Work Order ID 70260

DRAWING NO. D2580	TITLE 205 SKIDTUBE ASSEMBLY	REV. D	DART AEROSPACE LTD ENGINEERING ORDER		D.E.O. NO. D2580-D-1	SHEET NO. SHEET 1 OF 1	SCALE NTS
DRAWN <i>UP</i>	CHECKED <i>L</i>	MFG. APPR. <i>B</i>	APPROVED <i>MP</i>		DE APPR. <i>H</i>		
DATE 10.09.22	DATE 10.11.04	DATE 10.11.04	DATE 10/11/04		DATE 10.11.04

PURPOSE:

CHANGE ALL WELDED CROSSBOLT SPACERS TO SWAGED SPACERS

SECTION D-D & SECTION H-H ARE AMENDED AS FOLLOWS:

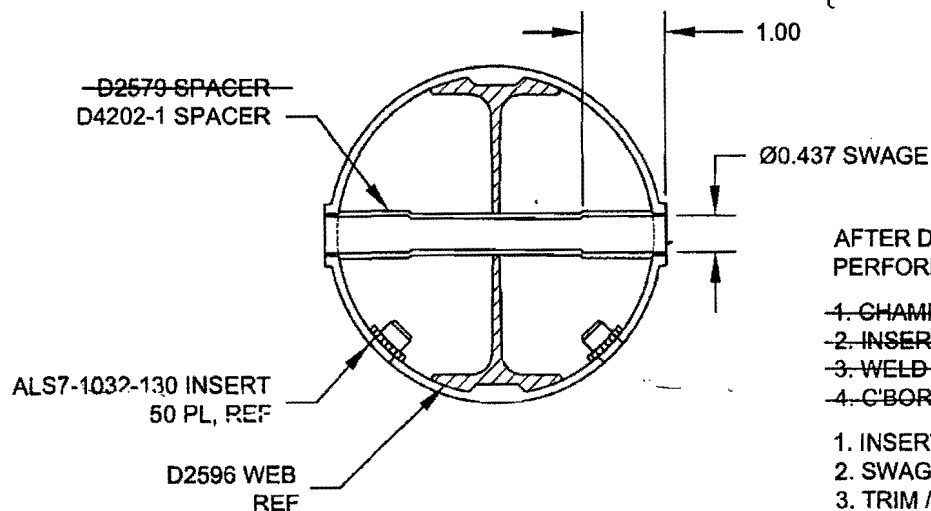
PARTS LIST IS AMENDED AS FOLLOWS:

WAS

QTY	QTY	PART NUMBER	DESCRIPTION
-041	-045		
20	24	D2579	CROSS BOLT SPACER

AFTER DRILLING AND BENDING ASSEMBLY
PERFORM THE FOLLOWING FOR Ø0.508 HOLES ONLY:

1. CHAMFER HOLE 0.050 X 45°
2. INSERT D2579 SPACER (20 PLACES)
3. WELD INTO PLACE AND GRIND FLUSH
4. C-BORE D2579 SPACER TO Ø0.437 X 1.00 DEEP

IS

20	24	D4202-1	SPACER
----	----	---------	--------

1. INSERT D4202-1 SPACER, 20 PL (-041) OR 24 PL (-045)
2. SWAGE TO Ø0.437 X 1.00 DEEP PER QSI 002
3. TRIM / GRIND FLUSH PER QSI 002
